1.0 INTRODUCTION

- 1.1 DTA Transportation Ltd (DTA) have been commissioned by Hinckley Investment LLP to review and response to the comments from Leicestershire County Council (LCC) in relation to the Transport Assessment (TA) and Framework Travel Plan (FTP) submitted in relation to the proposed development of an industrial unit for flexible B2/ B8 off Hammonds Way, Hinckley (planning ref: 25/01192/FUL).
- 1.2 The comments from LCC are set out in *italicised blue text* with the full response being attached at **Appendix A**.

4.1 This note address highways and transportation comments raised by Leicestershire County Council (LCC) in respect of current planning application 25/01192/FUL.

DRAWING TITLE
Visibility Splays

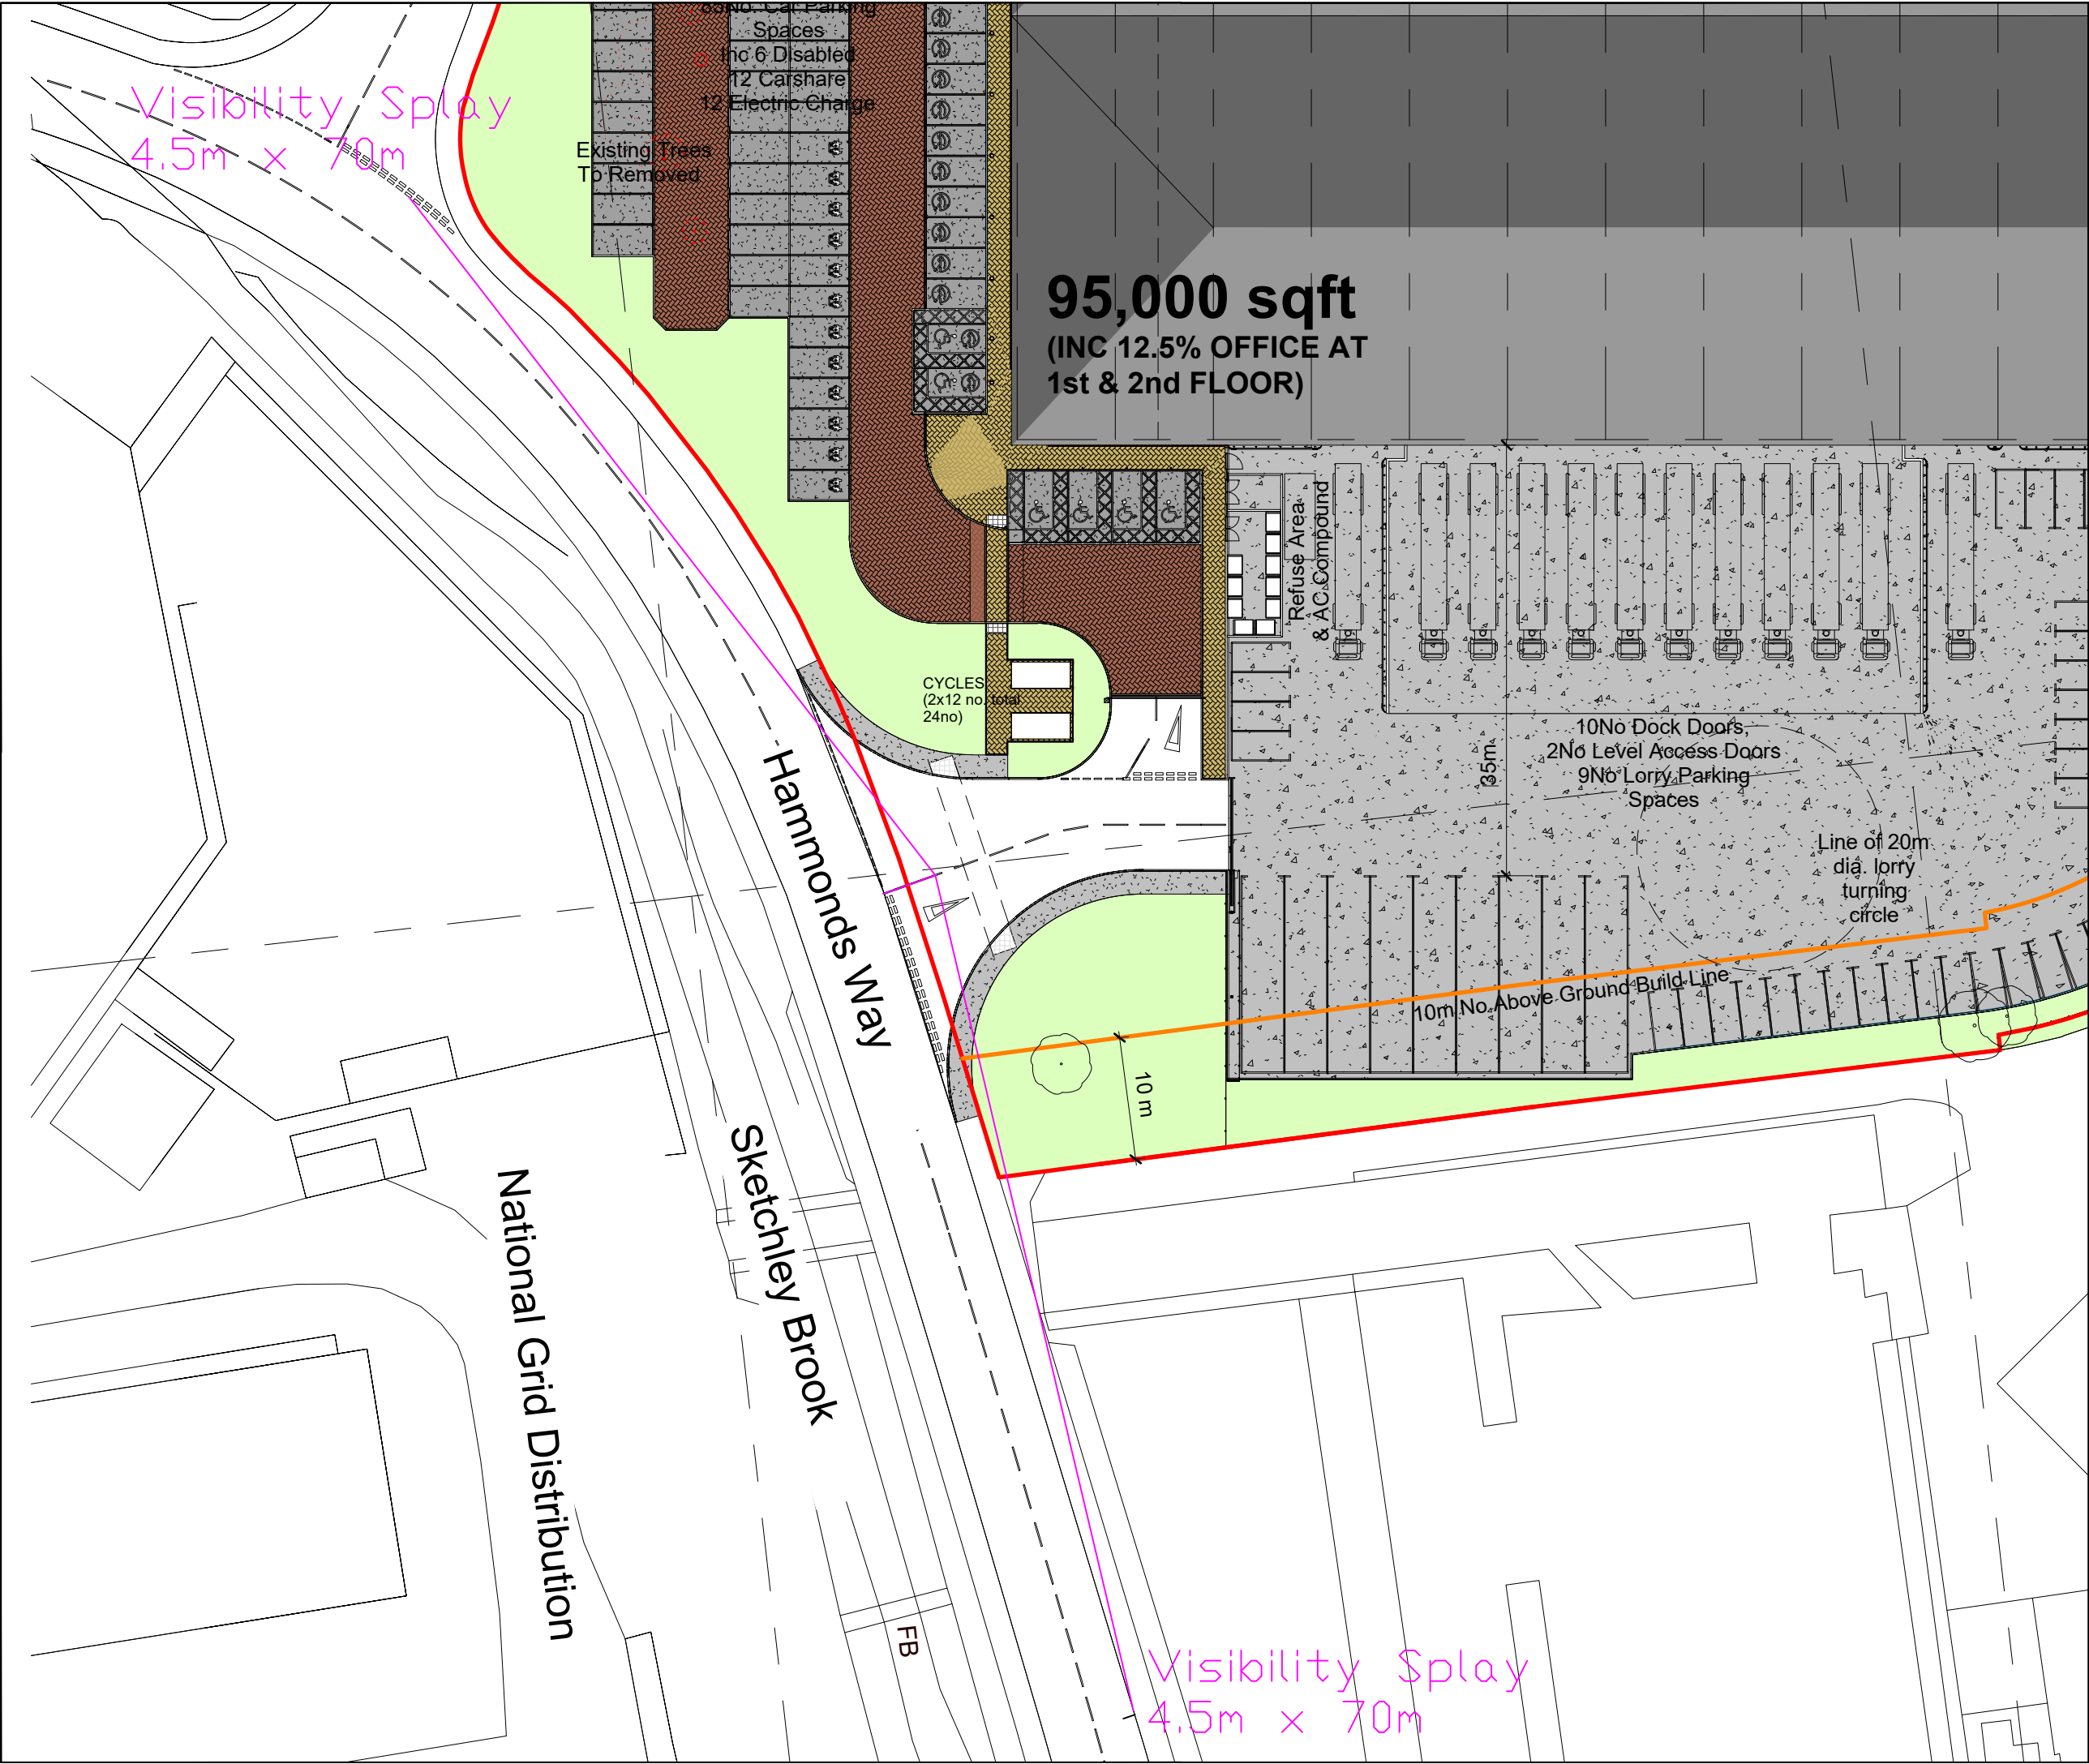
The LHA have reviewed the submitted drawings 27339-01 and 02 and make the following comments.

- Regarding the access design, the access width should be 7.3m to be in accordance with Part 3a and 3b, Table 4 - General geometry of employment and commercial roads of the LHDG, rather than the 7.0m proposed;*
- A 16m radii is shown, however this should be changed to 15m with 1 in 10 tapers as per Figure 9 of the LHDG;*
- A curve radius of 55m minimum on the centre line is also required as per Table 4, part 3 of the LHDG;*
- Vehicle visibility splays of 4.5m x 47m are shown on drawing 27339-02. These should however be in accordance with Table 4, part 3 of the LHDG meaning splays of 70m are required unless it can be demonstrated recorded speeds are lower; and*

- 2.2 Whilst the TA states a 7m width, this was a typo, and the drawings already show a 7.3m wide access.
- 2.3 Due to the location and angle of the access in relation to the existing highway, as well as the access into the car parking area within the site, it is not possible to achieve the required radii/ tapers and curve radii. It is also not considered that the access being considered is a major industrial access road given that it is only giving access to one unit of circa 8,825sqm.
- 2.4 The visibility splays have been updated to 70m and can be seen in **Drawing 27339-02a**.
- 2.5 The swept path analysis has been updated to be done at speeds of 15kph. These can be seen in **Drawing 27339-01a**.

DRAWING TITLE Proposed Footywa/ Cycleway

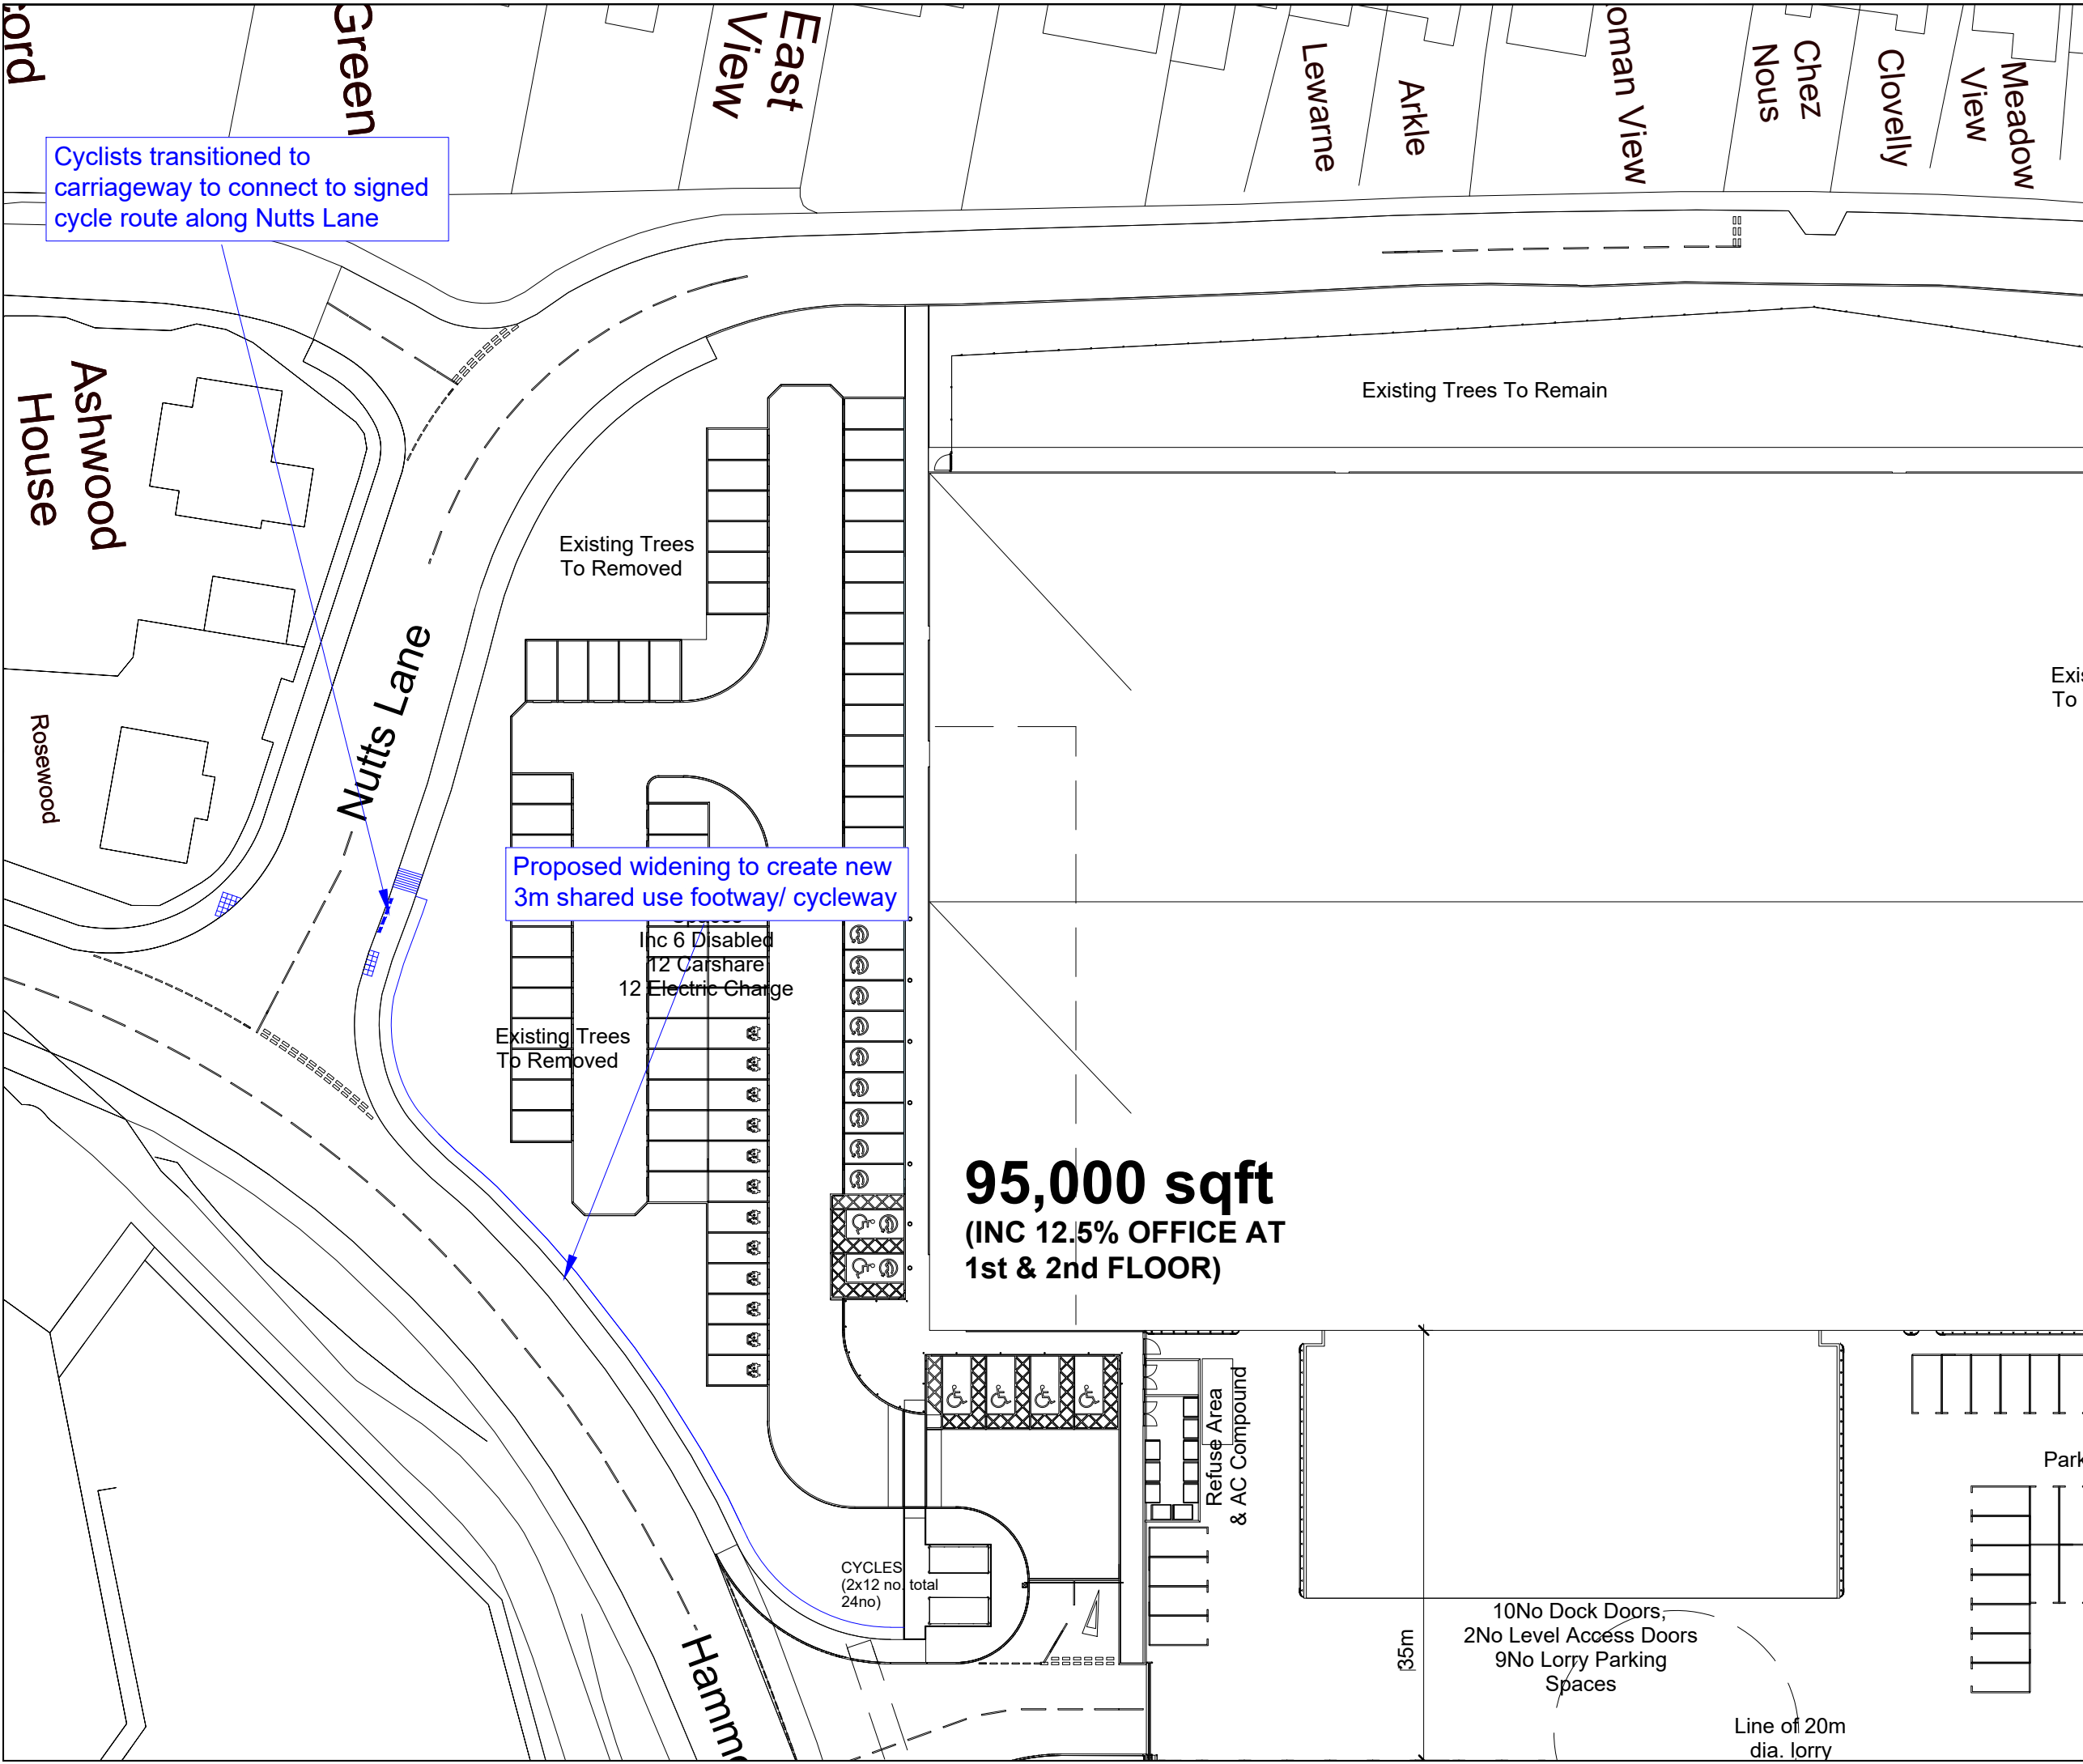
There is an existing shared footway/ cycle provision on the A5 island. The LHA would request that the Applicant develop proposals extend the footway/cycleway into Hammond's way and to the development site, as the layout drawing 27339-01 shows a cycle provisions being made within the development.

2.12 It is proposed to provide a new 3m shared use facility from the site access along Hammonds Way and into Nutts Lane around the boundary of the site. This would connect into the signed walking and cycle route through to the A5. This is shown on **Drawing 27339-03**.

Cyclists transitioned to carriageway to connect to signed cycle route along Nutts Lane

Proposed widening to create new 3m shared use footway/ cycleway
